Pentium® Processor Specification Update

Release Date: March, 1995

Order Number: 242480-002

2. *Mechanical/Thermal/Case Temperature Specifications for Pentium® Processor Heat Spreader Package*

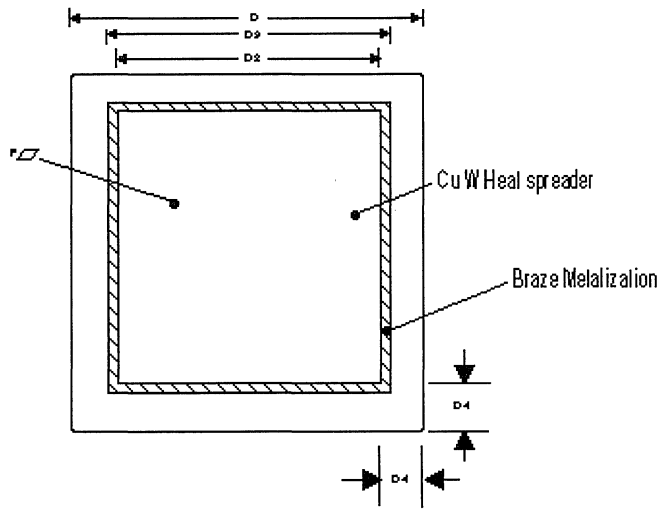
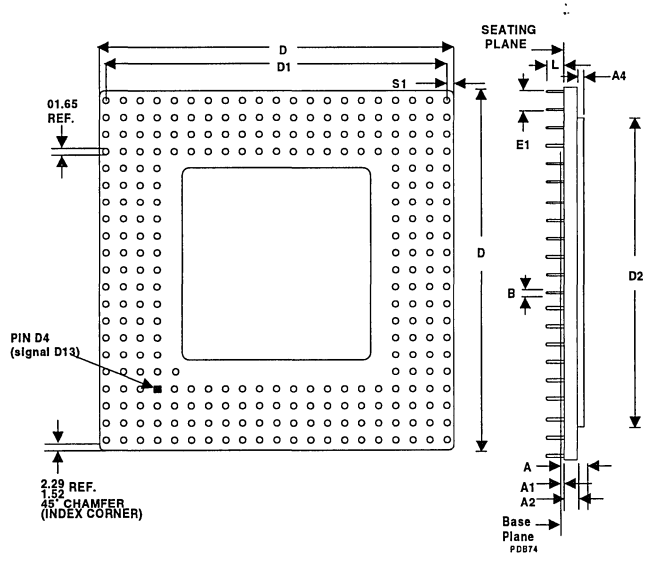
Following are the changes to the Pentium processor mechanical, thermal, and case temperature specifications necessitated by the addition of a heat spreader to the package for improved thermal performance of the die.

1. Figure 9-1 is changed to reflect the addition of the heat spreader.
2. Figure 9-2 added to show the top view of the package.
3. Table 9-2 updated.
4. The weight of the heat spreader package increases to approximately 2X the weight of the standard PGA package (70.7 grams vs. 33.2 grams).

21. Power-Up BIST Failure

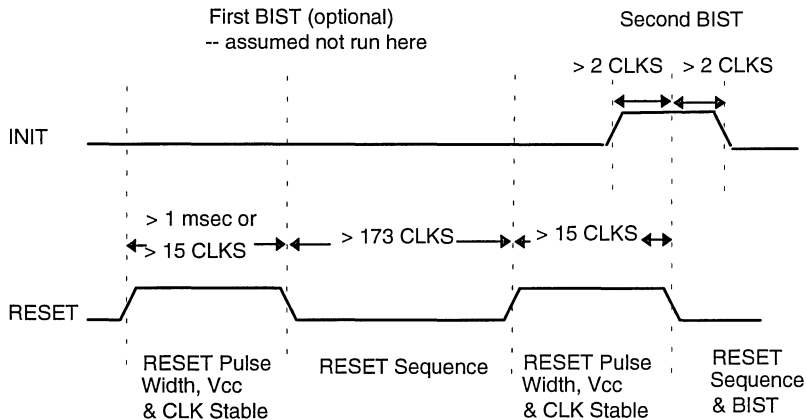
PROBLEM: The BIST (Built In Self Test) feature may fail.

IMPLICATION: Upon completion of BIST, a false failure may be reported. That is, a non-zero value may be returned in the EAX register, even though the part is operating correctly. As such, this erratum has no other product or system implications and is fully functional. To date, all observed false failures have returned a value of 20000H in EAX.

1. Invoke a double RESET — All false BIST failures have occurred during cold RESET. In order to accurately execute BIST, a double RESET sequence may be performed as shown in the figure below:

11. Package Change

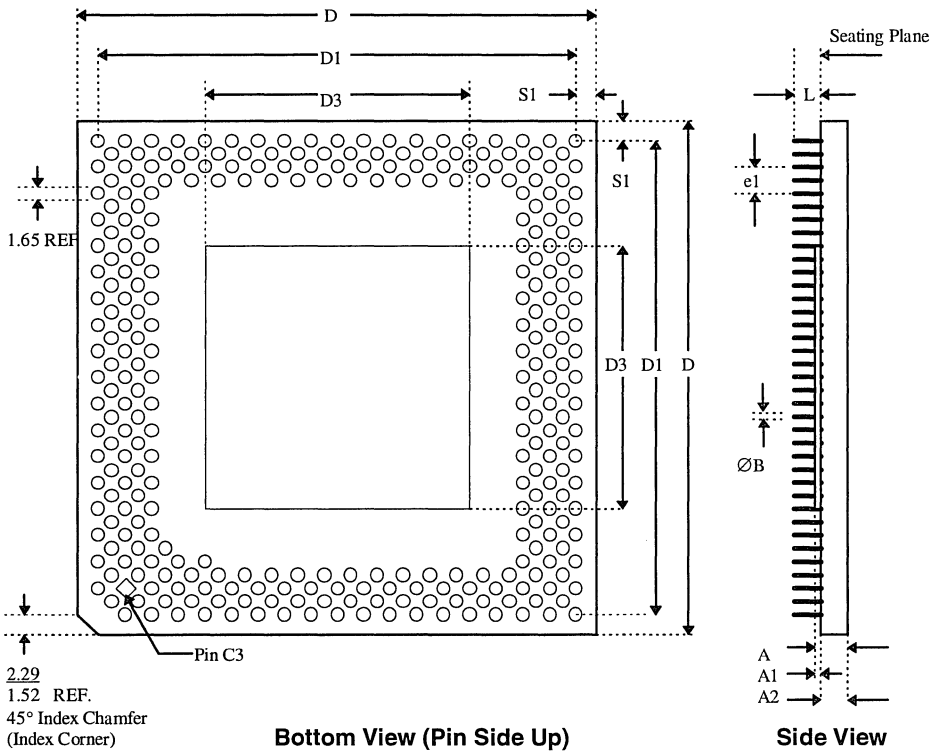
The C2 and future steppings implement a package conversion that removes the heat spreader from the top of the package, and replaces the metal lid covering the die with a ceramic lid. The package has the following dimensions:

11. Future Pentium® OverDrive® Processor FERR# Contention in Two-Socket Systems

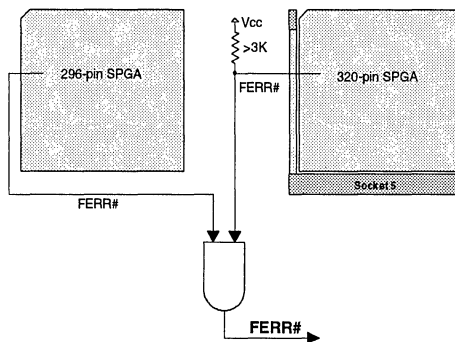
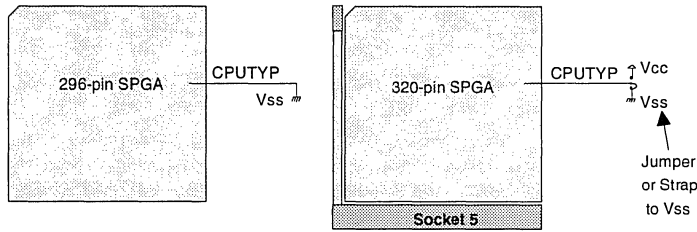
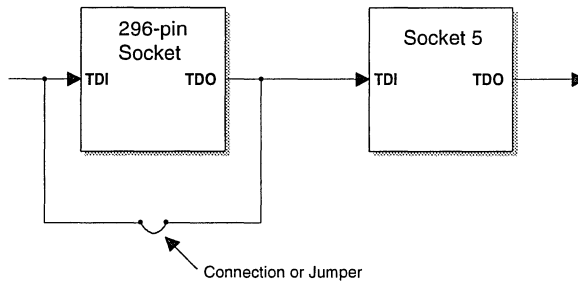
PROBLEM: When the Future Pentium OverDrive processor is plugged into Socket 5 of a two socket 75-, 90-, or 100-MHz Pentium processor system, the OEM processor shuts down following RESET to allow the OverDrive processor to drive the bus. In this case, the FERR# output of the 75-, 90-, and 100-MHz Pentium processor continues to be driven HIGH (inactive).

IMPLICATION: If the system uses the FERR# output of the OEM processor, and has the signal connected together between the two sockets (296-pin SPGA OEM socket and 320-pin Socket 5), contention on this signal is certain since the Future Pentium OverDrive processor, when placed into Socket 5, will also drive this output. This signal contention can cause component and even board reliability issues.

An external AND gate may be used to combine the outputs of the FERR# signals from the two sockets. A pull-up resistor ($\geq 3K\Omega$) is required on the FERR# output from Socket 5 in order to allow proper operation of both the Dual Processor and the Future Pentium OverDrive processor. See the following figure:

2. **Upgradability by modifying a two socket system to be a single socket system:** This workaround involves modifying a design that includes two socket sites (296-pin SPGA and 320-pin Socket 5) such that it effectively becomes a single socket design.

A Dual Processing two socket system must have CPUTYP tied to V_{SS} on the 296-pin SPGA OEM socket, and tied to V_{CC} on Socket 5 (320-pin SPGA). This workaround includes inserting a jumper on the Socket 5 CPUTYP signal (or strapping Socket 5 CPUTYP directly to V_{SS}) to make this the primary processor site. The system would then effectively become a single-socket design. NOTE: if a jumper is used, it must be set by the OEM prior to system sale (not by the end-user at the time of the Future Pentium OverDrive processor purchase and installation). This jumper would set the CPUTYP signal on Socket 5 to V_{SS} . If the same board design is used for DP, this jumper (or strapping option) may be set to V_{CC} for those systems, as shown in the following figure:

4DP. Address Parity Check Not Supported in Dual Processing Mode

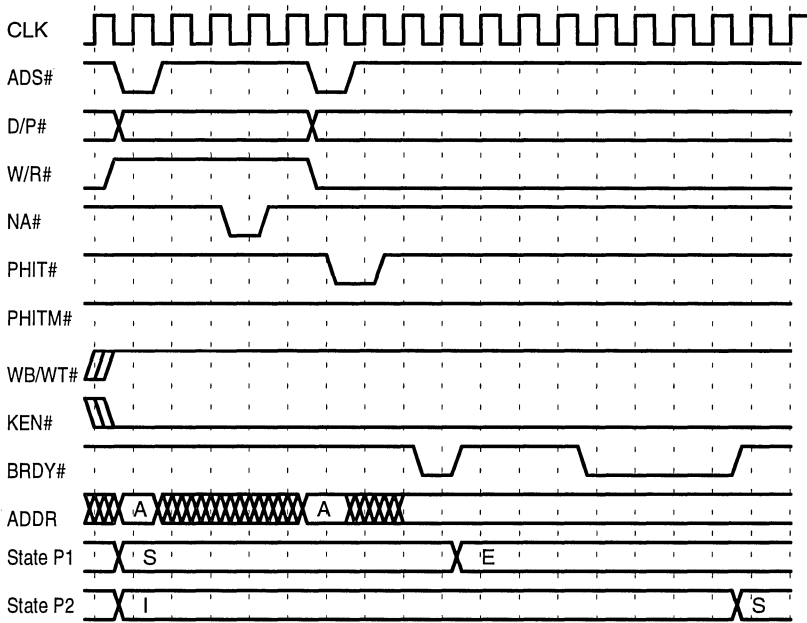
PROBLEM: This is a dual processor errata: There is a very short setup and hold time for the address bus lines in Dual Processing mode to support the single clock interprocessor snoop response required for cache coherency. In this case the 3ns setup specification is enough for the address to propagate to the cache but it does not allow enough time for the address to propagate to the parity calculation circuits. There is a chance that the APCHK# line will spuriously go active showing a parity error on the address bus.

IMPLICATION: Internal measurements of these address signals show that if the 3ns spec is met the addresses will be latched correctly. Since the parity portion of the circuitry does not meet this timing there is no way to guarantee the APCHK# output is valid. Systems using the APCHK# pin will perform the APCHK# interrupt error routines.

WORKAROUND: Ignore APCHK# in a dual processor environment.

6AP. *HOLD during a READ from Local APIC Register May Cause Incorrect PCHK#*

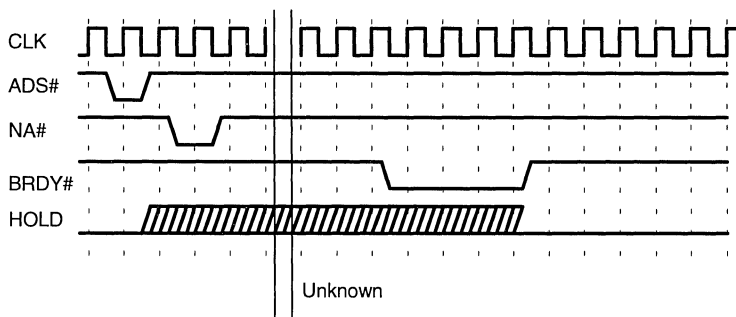
PROBLEM: If the processor is reading one of its local APIC registers when the HOLD pin is asserted, PCHK# may be asserted for one clock even though there is no data parity error. PCHK# will be asserted if the values of the data bits [D31:0] and the parity bits [DP3:DP0] do not match during the HOLD/HLDA transaction.

IMPLICATION: This will impact a system that implements or responds to parity checking by the CPU, the response will be specific to the parity error recovery routines implemented in the system. If parity is not implemented in a system, there will be NO adverse effect from this erratum since there is no real parity problem.

WORKAROUND: If data parity checking and the local APIC are both enabled, deassert PEN# (parity enable) during the time that HOLD is active. This signals to the processor that parity is not being driven from the system and PCHK# will never be driven in response to this data transfer.
